**REVISED PETITION TO AMEND
THE COMMISSION'S CERTIFICATION OF THE
ABENGOA MOJAVE SOLAR PROJECT**

09-AFC-5C

October 29, 2013

Abengoa Mojave Solar Project
Mojave Solar, LLC
13911 Park Avenue, Suite 206
Victorville, CA 92392

LEGEND

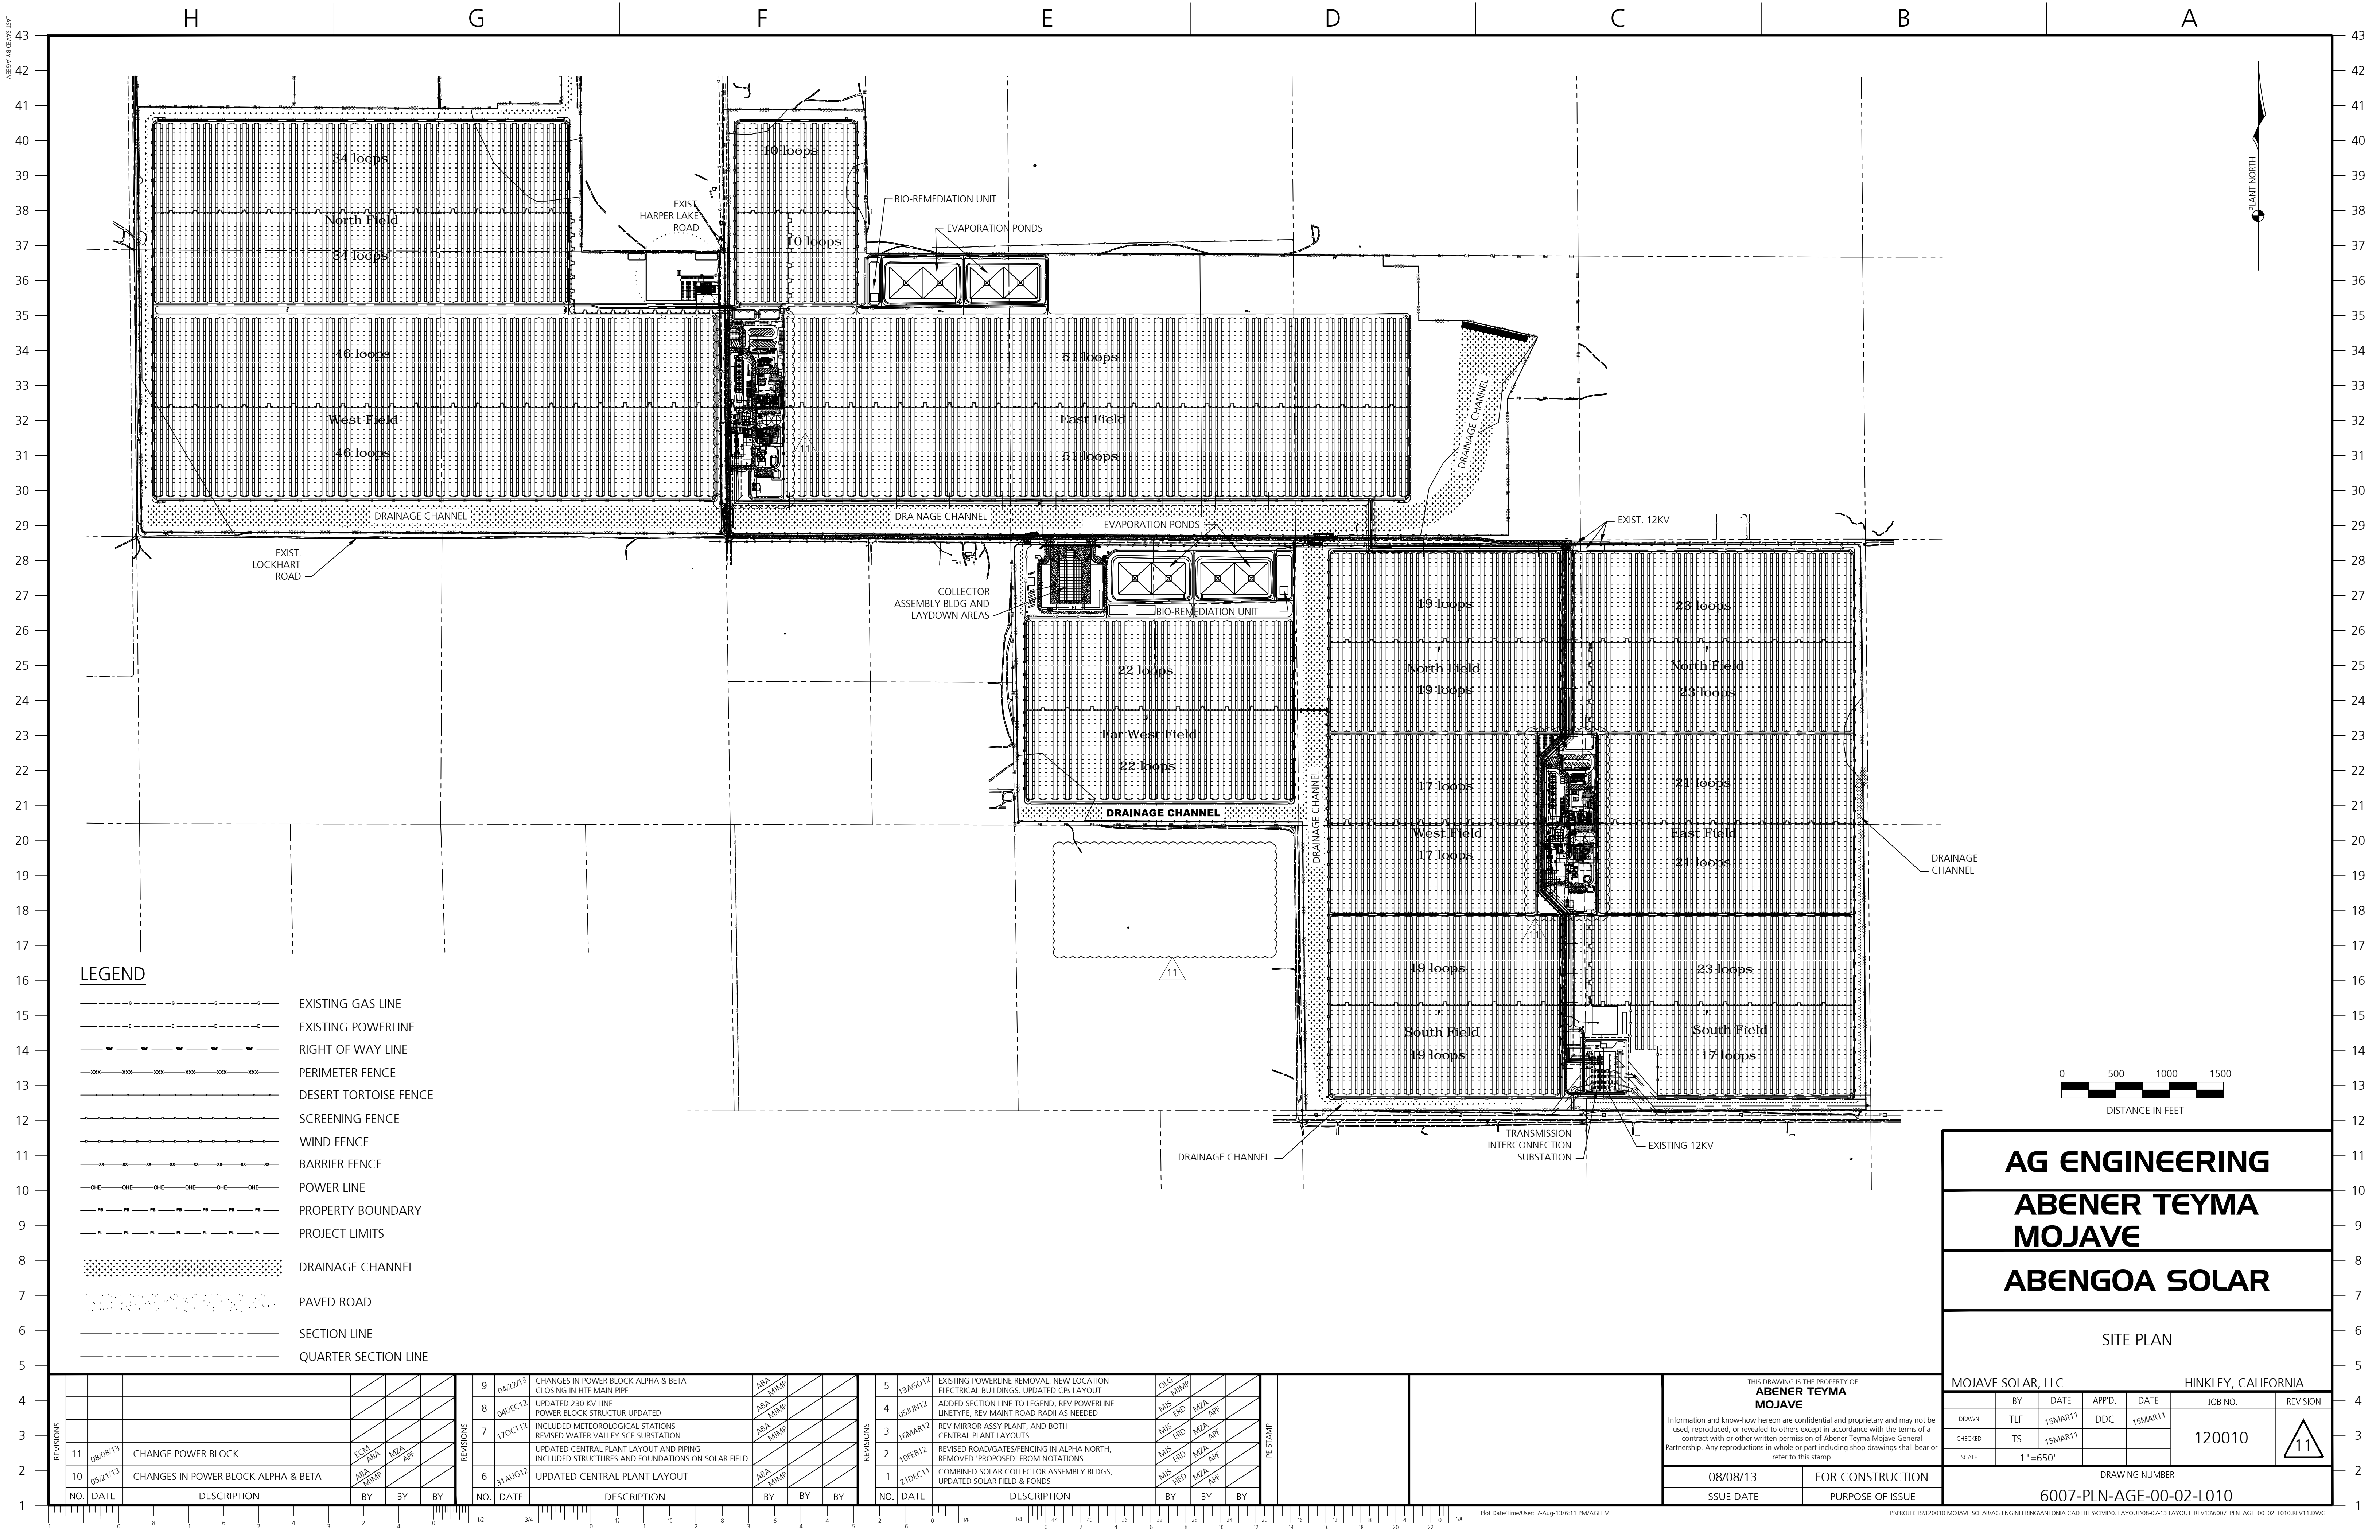
- Modifications to the MSP Project Description
 - Modifications to the general arrangement of the Alpha and Beta power blocks;
 - Remove the existing low boilers and high boilers cleaning distillation VOC control system and install a scrubbing and carbon adsorption VOC control system;
 - Update the facility component counts with revision to the fugitive emissions inventory;
 - Replace the currently permitted two (2) Tier II 4,190 hp⁵ (3,125 kW) emergency generators with two (2) Tier II 2280 kW units;
 - Reduce the currently permitted Tier II emergency generators' stack height to 30 feet above ground level (AGL);
 - Replace the currently permitted two (2) 346 hp Tier III fire pump engines with two (2) larger 575-617 hp Tier III engines; and
 - Remove the operational testing restriction of one (1) emergency engine per hour with the simultaneous testing of all emergency equipment.

The modifications to the project description are needed to reflect the changes to the MSP's general arrangement and replacement of certain equipment that has occurred during the final detailed engineering design phase for the MSP. The modifications to the conditions of certification are needed to conform the conditions to the proposed changes to the project description.
